Variance Petition No. 201404420

INTENT

CITI WINE AND SPIRITS

PROPOSED NORTH ELEVATION

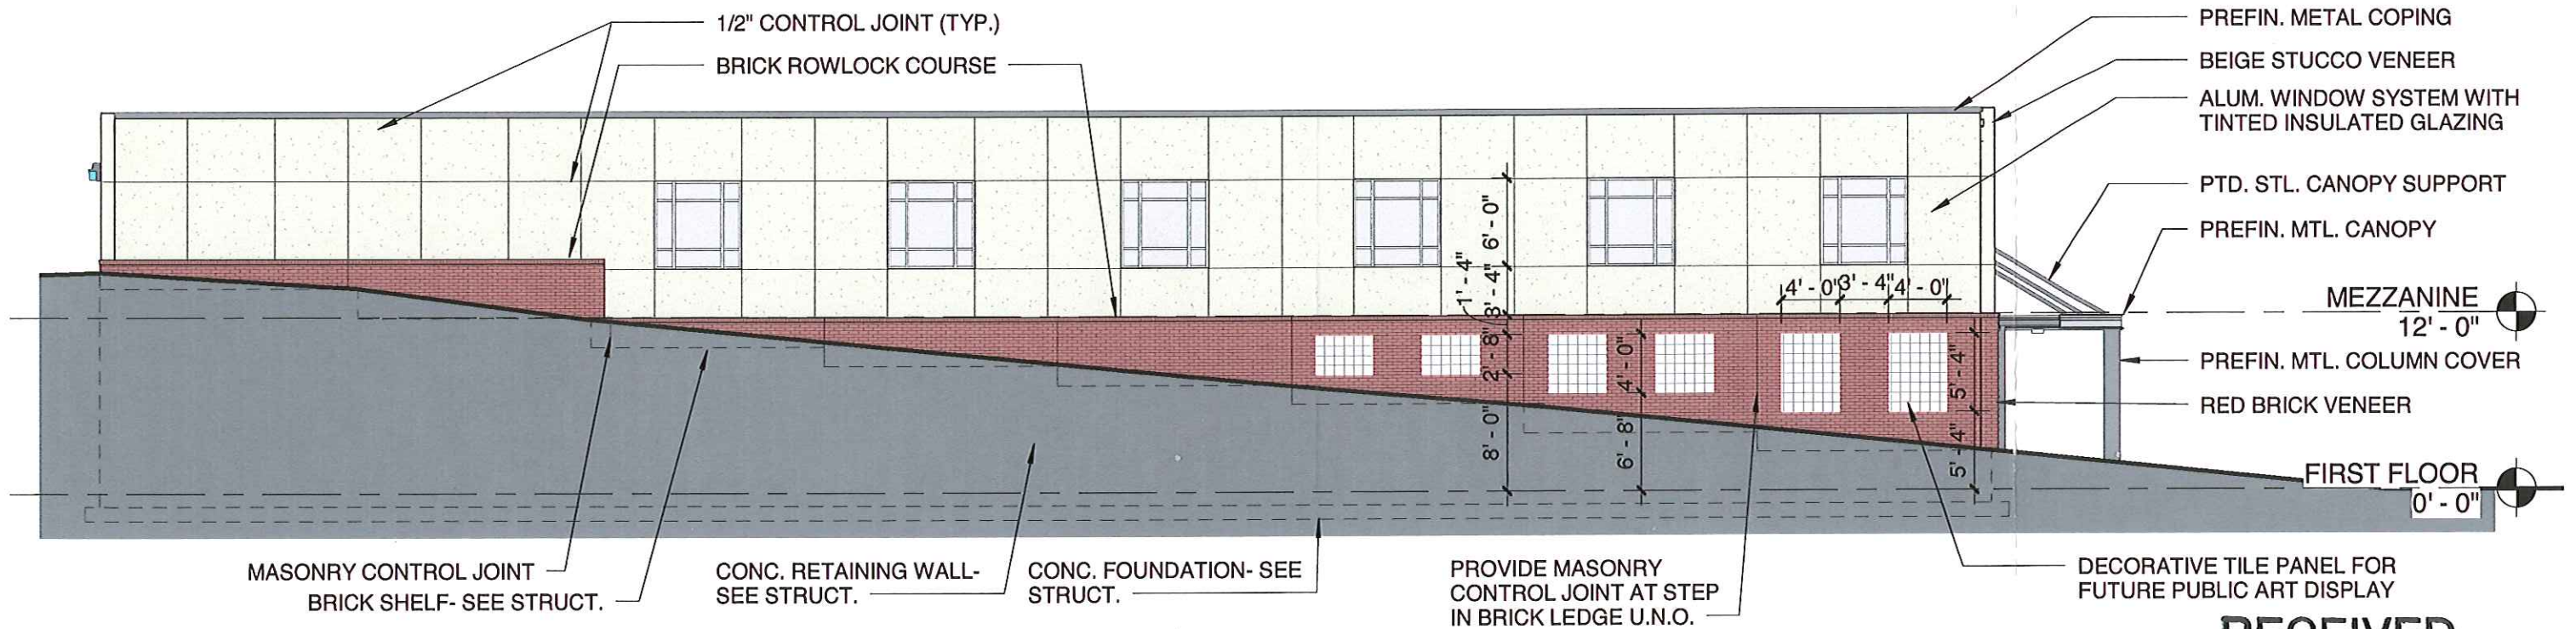
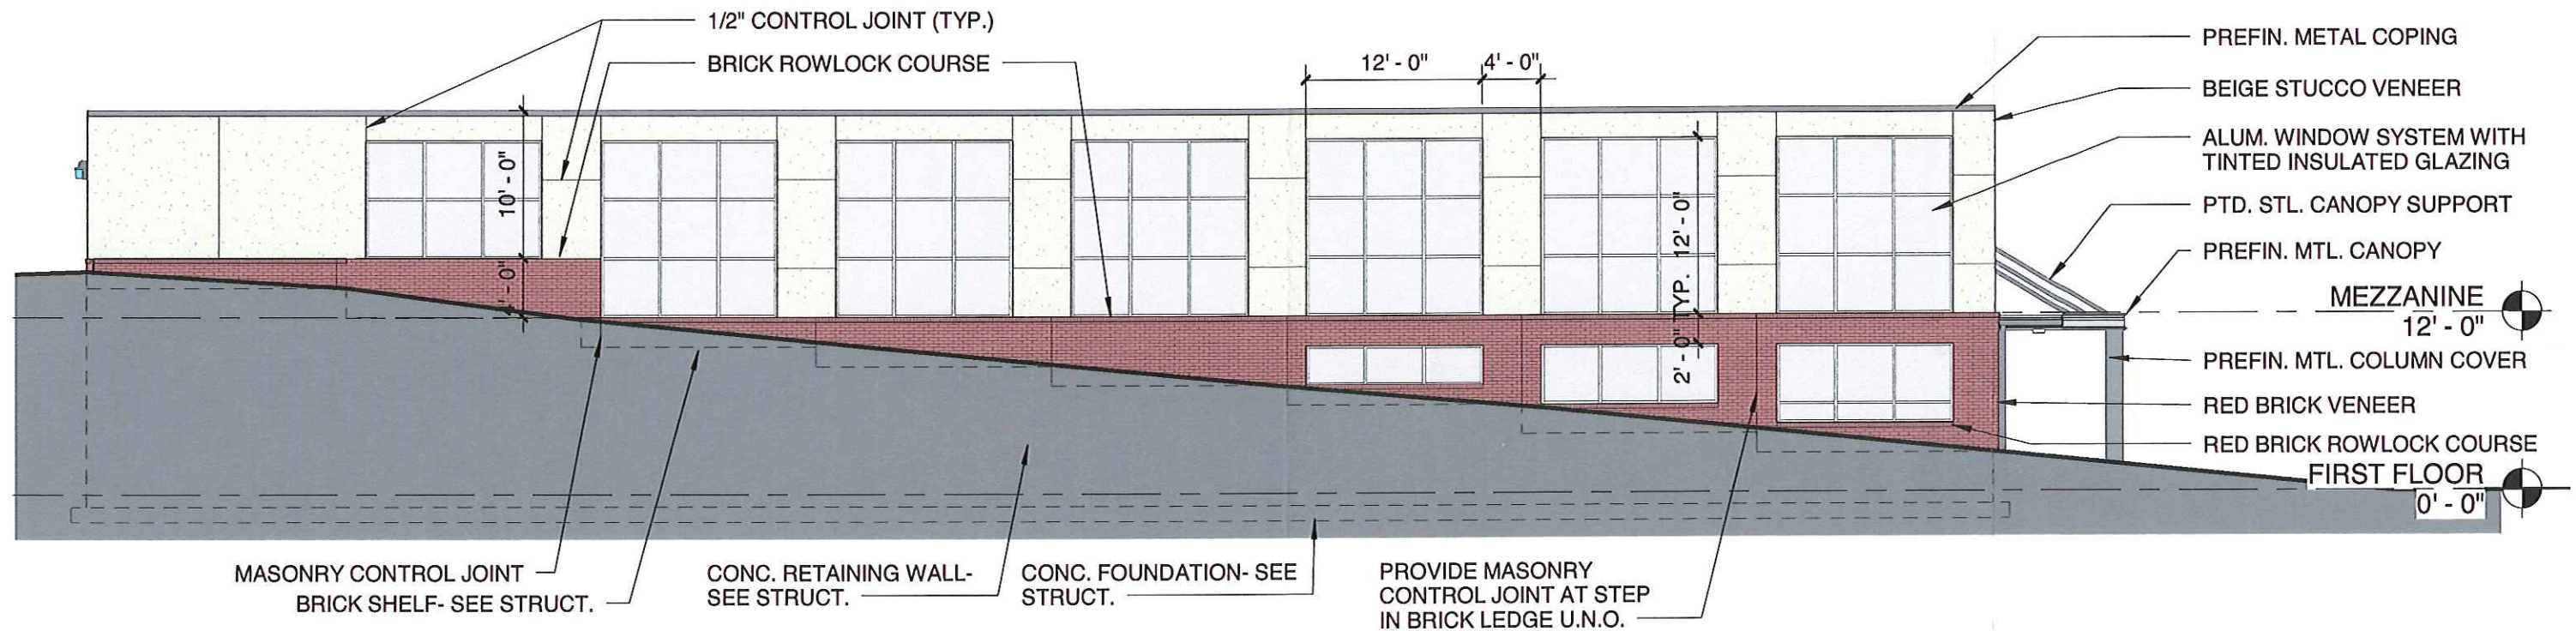
A primary purpose of the Overlay District is to enhance local aesthetic and functional qualities and to simulate business. While reduction of glazing on the eastern portion of the north façade may be appropriate, the proposed elevations do not provide glazing on the western portion, where pedestrian engagement is likely to stimulate business. Eliminating the glazing requirement along the entire north façade would eliminate pedestrian engagement which the Main Street Overlay District intends to create. Based on these considerations, staff is of the opinion that this condition, as presented, has not been satisfied.

Staff has reviewed the request relative to the variance standards contained in the Sandy Springs Zoning Ordinance. Staff recommends a condition on the western most portion of the north façade include one set of windows as highlighted on the *Original North Elevation* presented by the applicant. This window would allow some glazing to be retained along the north façade where pedestrian engagement will occur along the sidewalk while granting relief along the eastern portion of the north façade where there are topographic challenges. Additionally windows on the upper story of the north façade should match the size and pattern of those on the upper story of the *West Elevation*. This condition would also allow increased glazing on the north façade by increasing the number of windows. Based upon this review, staff recommends **APPROVAL CONDITIONAL** of the variance request from Section 12B.8.F (2) (c) (i) of the Zoning Ordinance for relief from the 60% glazing requirement on a ground level façade for construction of a new building.

- 1) To construct a new building as shown on the site plan dated received December 2, 2014 by the Department of Community Development.
- 2) Provide a window on the western-most portion of the north façade as shown on the *Original North Elevation* dated received December 2, 2014 by the Department of Community Development.
- 3) Provide windows on the upper story of the north façade which match the size and pattern of those on the upper story of the *West Elevation* dated received December 2, 2014 by the Department of Community Development.
- 4) To construct a new building as shown on *Proposed North Elevation* dated received December 2, 2014 by the Department of Community Development.
